**PSEG** Public Service  
Electric and Gas  
Company

HOPE CREEK GENERATING STATION  
DOCKET NO. 50-354  
FSAR COMMITMENT STATUS THROUGH JULY 1984

ATTACHMENT I  
HOPE CREEK GENERATING STATION  
FSAR COMMITMENT STATUS THROUGH JUNE 1984

FIGURE 9.1-3 *sheet 1 of 4*

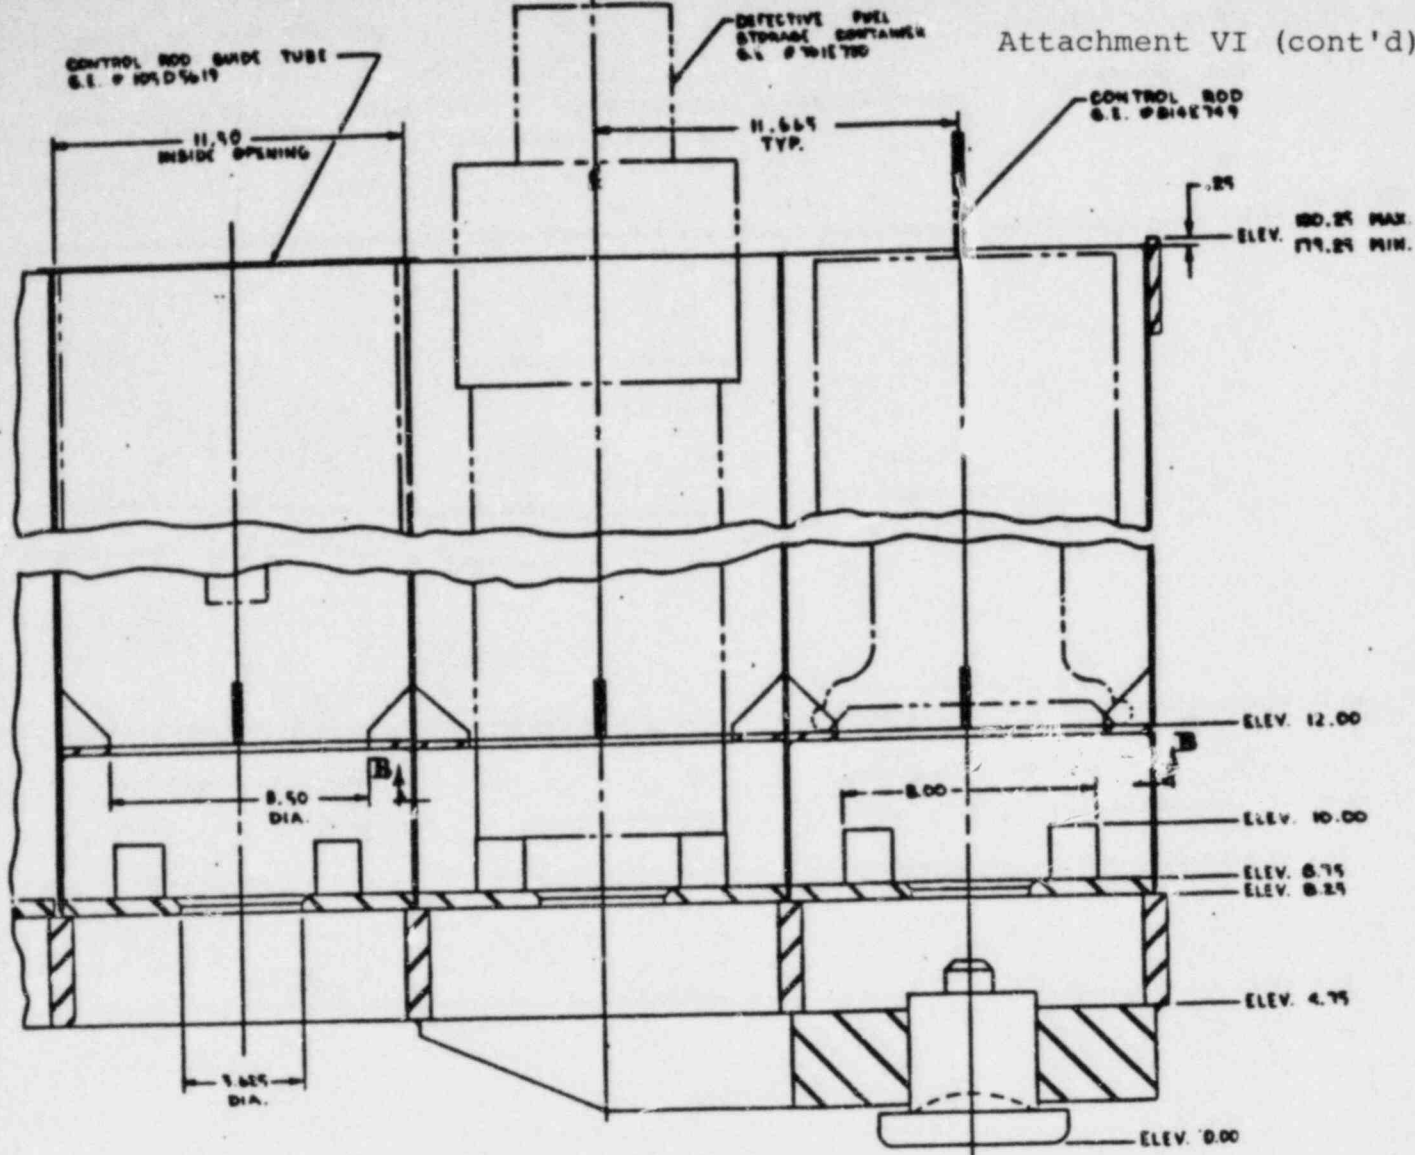
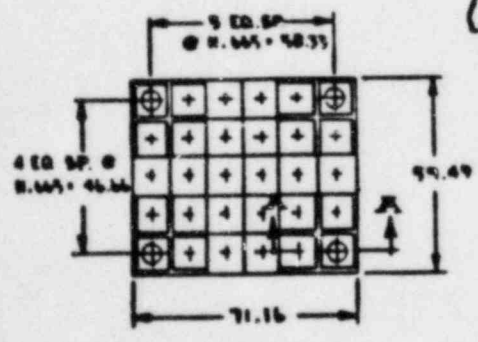
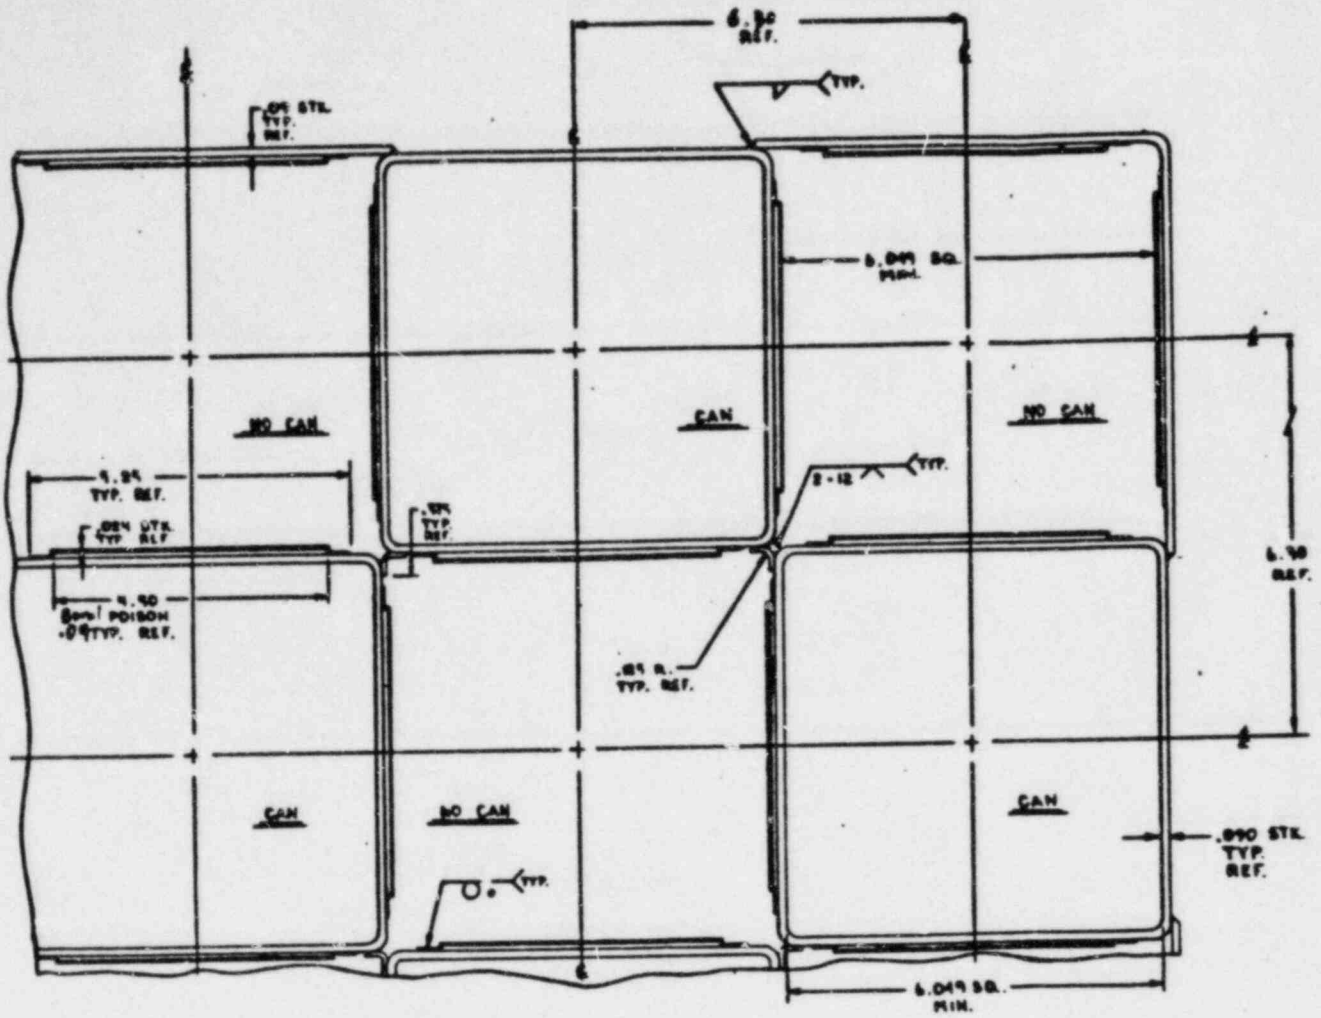
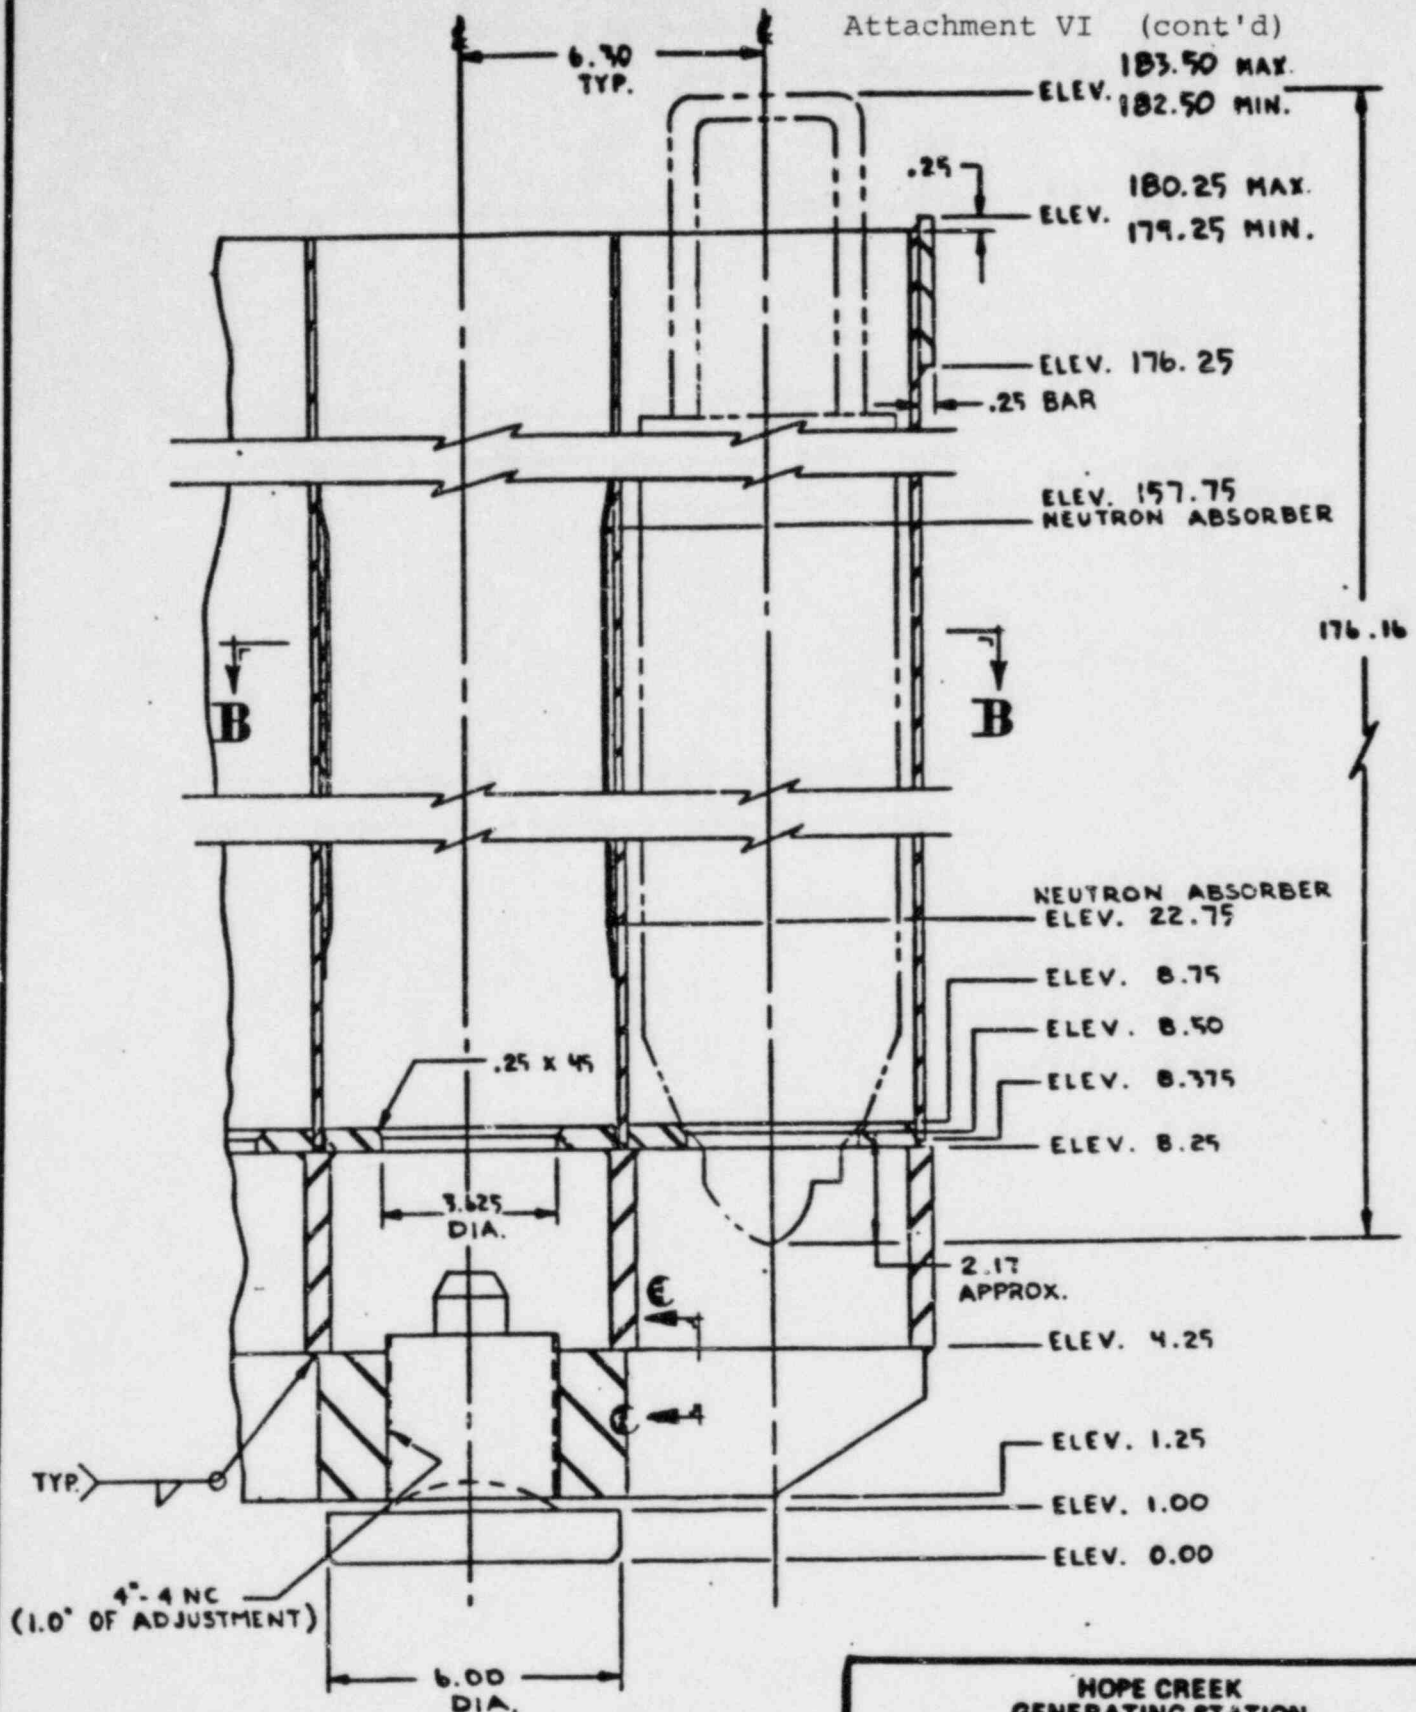
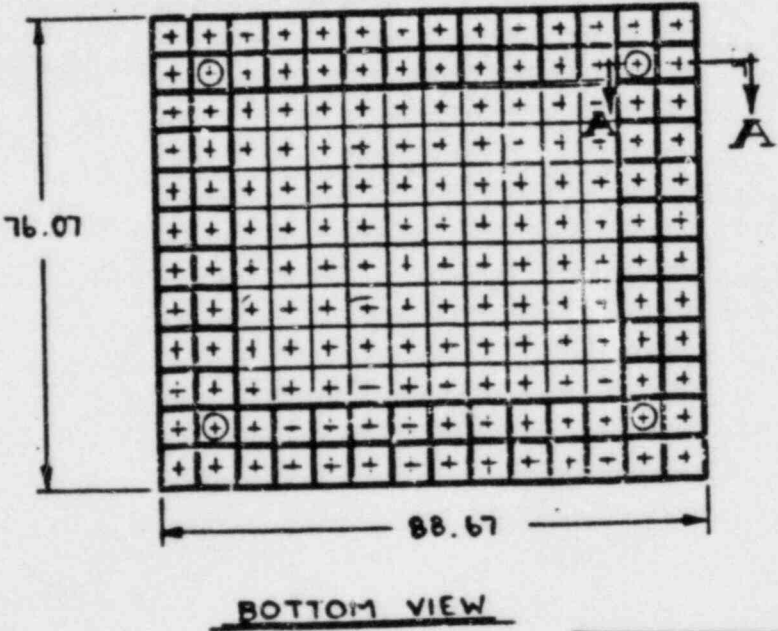
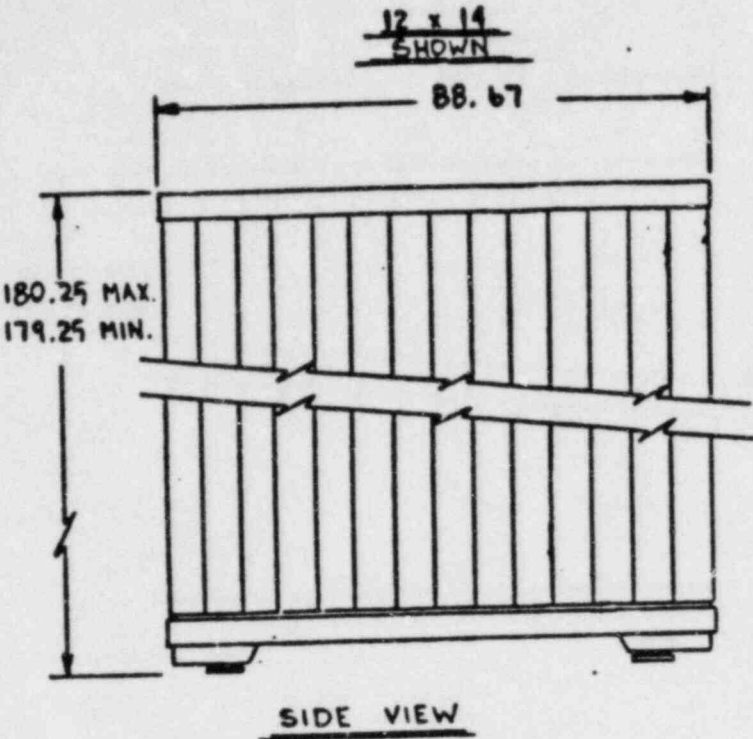
QUESTION 410.39 (SECTION 9.1.2)

Without the spent fuel storage rack design details, the results of an analysis of impact onto the racks and the bundle-to-bundle fuel spacing, the staff cannot make any favorable conclusions about the design. Provide this information in the FSAR.

Section 9.1.2 and Figure 9.1-3 have been revised to include  
^ The spent fuel rack design details. ~~will be available by June~~  
~~1984, and will be added to Section 9.1.2.~~
